From: [Joshua de block](#)
To: [*CI-StPaul Contact-Council](#)
Subject: Bike Plan
Date: Tuesday, April 23, 2024 9:03:25 AM

From: [Tim M](#)
To: [*CI-StPaul Contact-Council](#); [#CI-StPaul_Ward7](#); [#CI-StPaul_Ward6](#)
Subject: St Paul Bike Plan Comments from Ward 7 Resident
Date: Tuesday, April 23, 2024 11:05:35 AM
Attachments: [image.png](#)

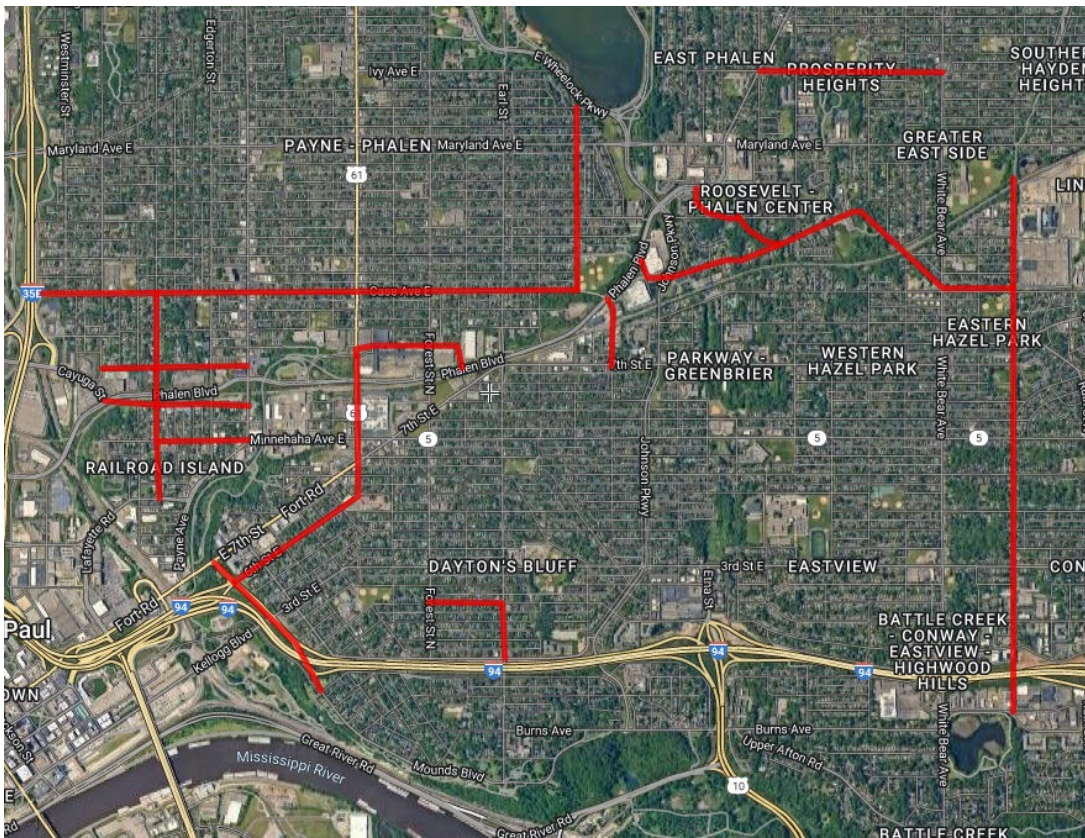
Railroad Island - There's a reason why this neighborhood has its name. By being fenced in on all sides by railroads, it requires bikers to go out of their way to go north or west of the neighborhood. The Cayuga Street station area plan had identified a reconnection of the former bridge over Phalen of Burr Street, and a connection from Bush Ave to Cayuga, not only creating a good connection for the future Purple Line but also to the Gateway Trail.

Other routes identified include: Case Ave, Whittall St, Wells St including an alleyway connection to Seeger Square Minnehaha Ave west of Edgerton, Duluth St north of Phalen and Atlantic south of Phalen

Here's an image of the routes that I've mentioned.
